TM-783
1650.000
CCI Report No. 370-105

# REVIEW OF QUESTIONS POISED BY JEFF APPEL ON SATELLITE REFRIGERATOR DESIGN

PREPARED UNDER FERMILAB SUBCONTRACT NO. 92690
BY CRYOGENIC CONSULTANTS, INC.
ALLENTOWN, PA.

4 April 1978

FIGURE 1

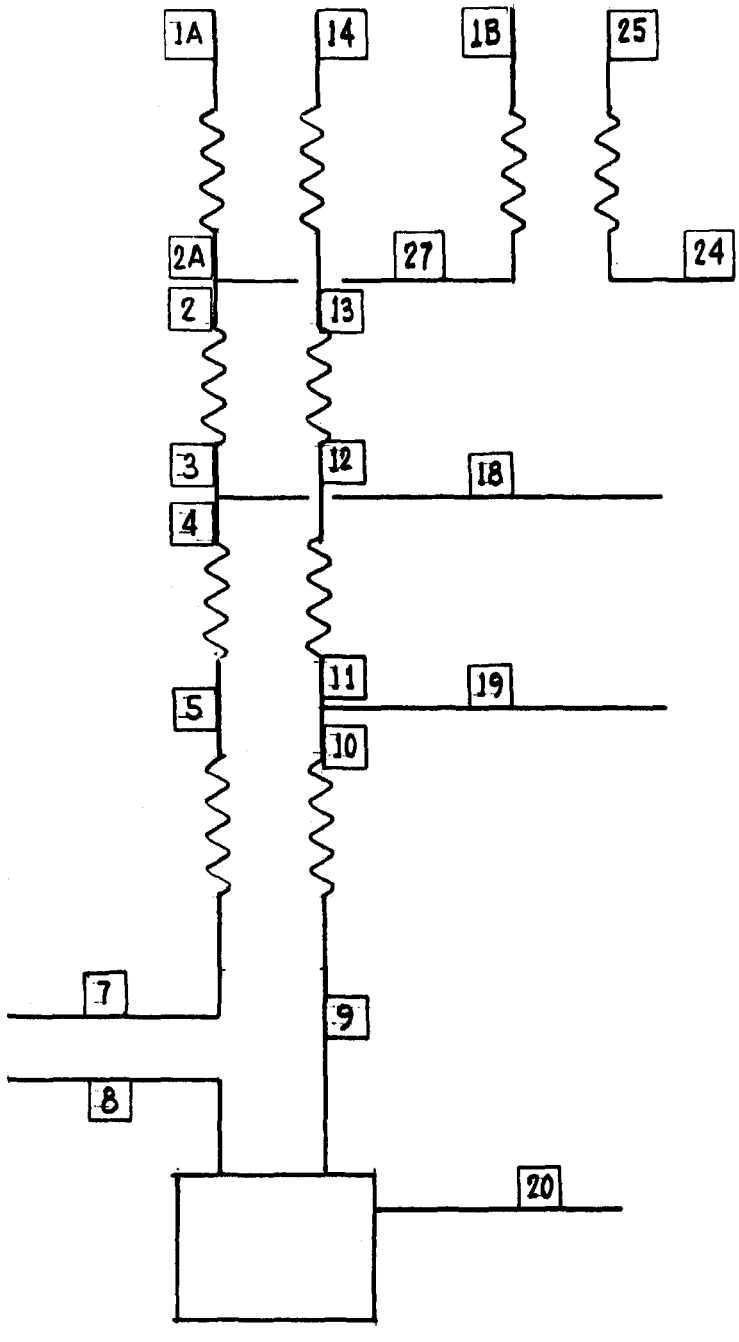
1. What is the temperature between exchangers II and III (high pressure gas) when the refrigerator operates in the satellite mode?

Temperature distribution in heat exchangers during satellite mode operation.- It is assumed that the process of the satellite refrigerator is as shown in Figure 1. Process points are as indicated in Table I:

The Table III data indicate that for exchanger II $\frac{Q}{\Delta T_m}$ will be approximately 10% larger than the value calculated from Table I. When the temperature of Point 2 drops, duty Q of the heat exchanger will increase, while $\Delta T_m$ will decrease. To obtain a change of 10%, Q will increase by 4% and $\Delta T_m$ will decrease by 6%. Then the new temperature of Point 2 will be approximately 71°K.

It should be realized that small changes in flow ratio between streams 1 and 14 will have a significant change on the performance requirements of the individual heat exchangers. For this reason, control of the cold end of exchanger II probably can be exercised with the same vapor pressure thermometer (nitrogen charged).
